Access Compliance Report

Public Rights-of-Way

(Curb Ramps)

Intersection ID: 10019976	Main Street: ARENA_BV	Cross Street: N/A	Location: NE
ADA ID: 7C45D358ADDC	Ramp Type: PerpDiag	Initial Pass/Fail: Fail	Overall Compliance: No
Severity Score: 21.25			
Codes/Mitigation Info/Possible Solution		Field Measurements/Component Compliance

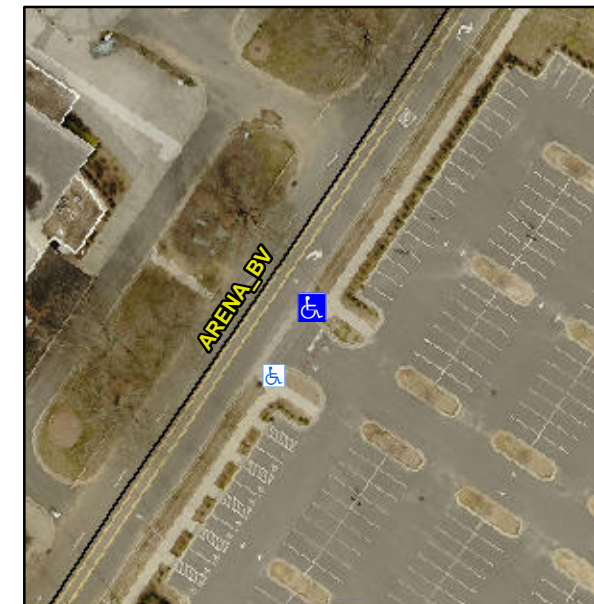
Not Found, R304.5.1, R304.2.2

Compliance	Description	Data	Compliance	Description	Data
N/A	Ramp Length (in)	95.0	No	Ramp Slope (%)	8.8
No	Ramp Width (in)	47.0	Yes	Ramp XSlope (%)	1.3
N/A	Flare Type LT	N/A	N/A	Flare Type RT	N/A
N/A	Flare Slope LT (%)	N/A	N/A	Flare Slope RT (%)	N/A
N/A	Flare Traversable LT?	N/A	N/A	Flare Traversable RT?	N/A
N/A	Landing Length (in)	N/A	N/A	DWS Provided?	N/A
N/A	Landing Width (in)	N/A	N/A	DWS Contrast?	N/A
N/A	Landing Slope (%)	N/A	N/A	DWS Length (in)	N/A
N/A	Landing X Slope (%)	N/A	N/A	DWS Full Width?	N/A
N/A	Landing Curb? (Y/N)	N/A	N/A	DWS Offset (in)	N/A
N/A	Shared Landing?	N/A			
N/A	Gutter Ponding?	N/A	N/A	Gutter Slope (%)	N/A
N/A	Gutter Lip Ht (in)	N/A	N/A	Gutter X Slope (%)	N/A
N/A	Painted X Walk1?	No	N/A	Painted X Walk2?	No
	X Walk 1 Direction	To NW		X Walk 2 Direction	To SW
N/A	X Walk 1 Width (in)	N/A	N/A	X Walk 2 Width (in)	N/A
	X Walk 1 Slope (%)	4.1		X Walk 2 Slope (%)	1.4
	X Walk 1 X Slope (%)	0.3		X Walk 2 X Slope (%)	5.8

Remove & Replace Curb Ramp With Two New Directional Ramps or Equivalent.
